Network Video Recorder

Version: V5.04.065 build250530

Release Note

Firmware Version:	V5.04.065_build250530
Firmware	SDK Version:	6.1.9.48
Basic	Play Library:	6.0.1.52
Information	Web component:	V5.1.12_R0102build250522
	OpenSDK Version:	2.15.3 (Ezviz), 2.14.1 (OTAP)

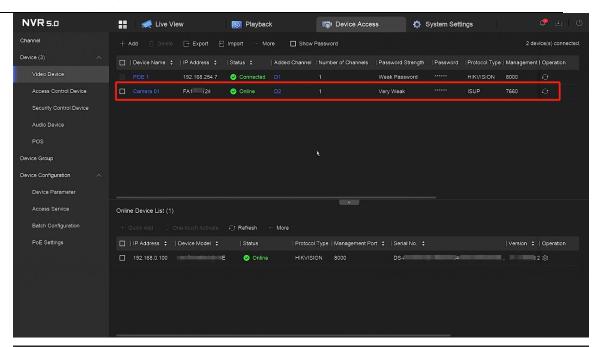
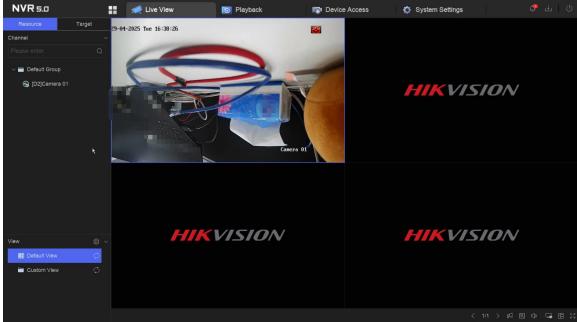
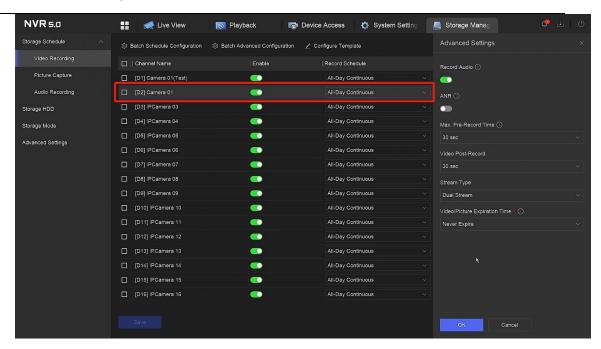
Support to add 4G & non-4G Hikvision IP camera (non-solar models) whose support ISUP5.0
protocol;

It can support to do live view, video&audio parameter configuration, recording schedule, two-way audio, remote PTZ control, receive alarms, update (online update, local update, FTP update), sync time, jump to web for the IP camera.

- a. No support to configure/batch configure these IP camera's IP address;
- b. No support the dynamic mosaic function if adding via ISUP5.0 even when IP camera support dynamic mosaic by themselves.

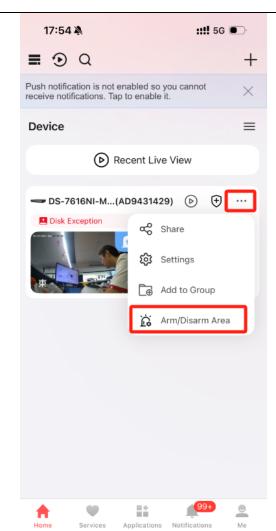
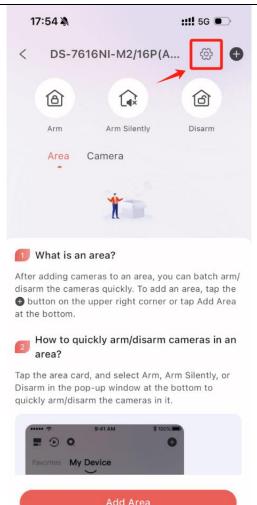
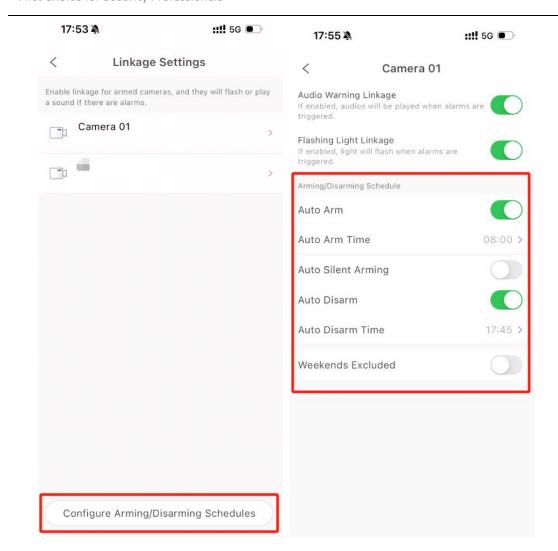
2. Support configure arming/disarming schedules on HC, auto arm/silent arm/disarm each channel at specific time (hour:mintue);

Note: It will support holiday schedule when Hik-Connect new version 6.9.300 released.

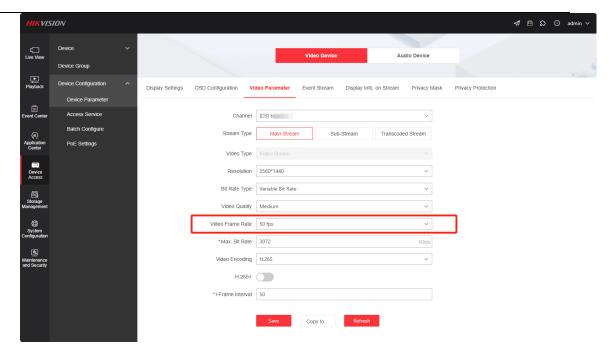
3. Support to add high frame rate IP camera via Hikvision protocol;

Support to add Hikvision 2MP @120/100fps, 8MP @50/60fps, 4MP @50/60fps IP cameras, it can configure video&audio parameter, full frame rate video recording and exporting, local/remote live view and playback.

Note: High frame rate is conflict to smart function.

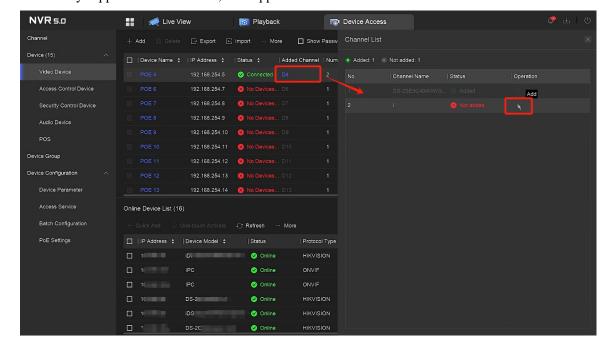
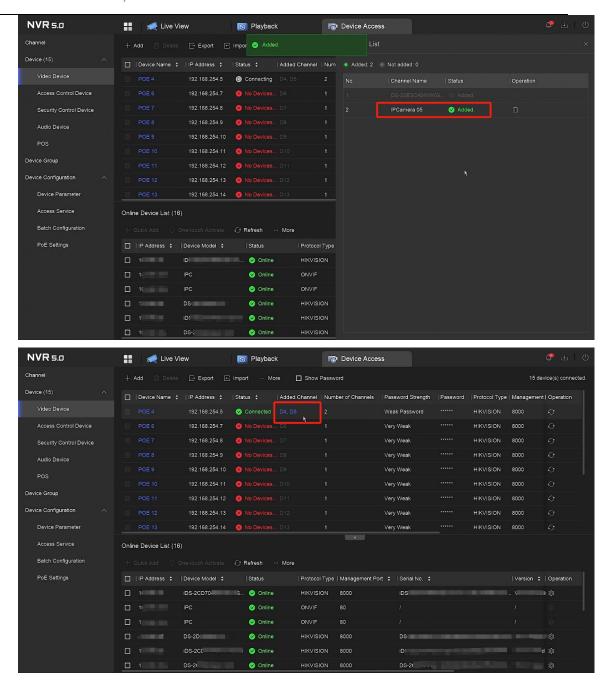
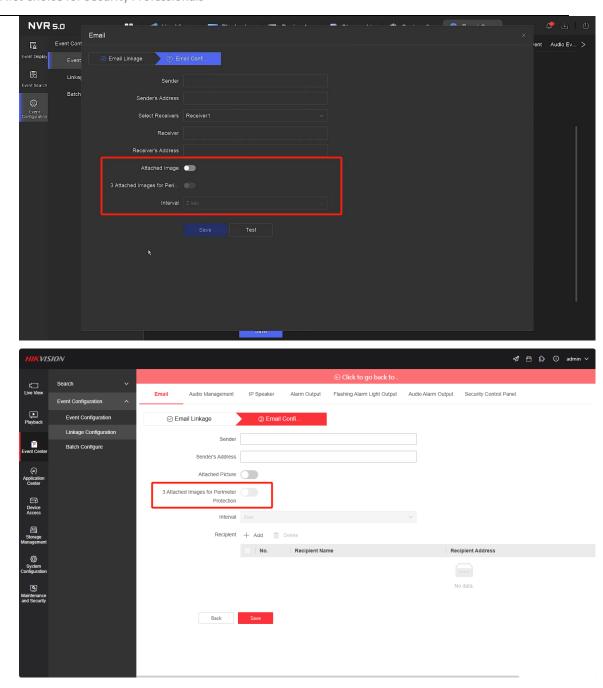
4. Support to add multi-cahnnel IP cameras via POE, you can add the other channels under Video Device menu;

Note: Only support from local GUI, not support on web.
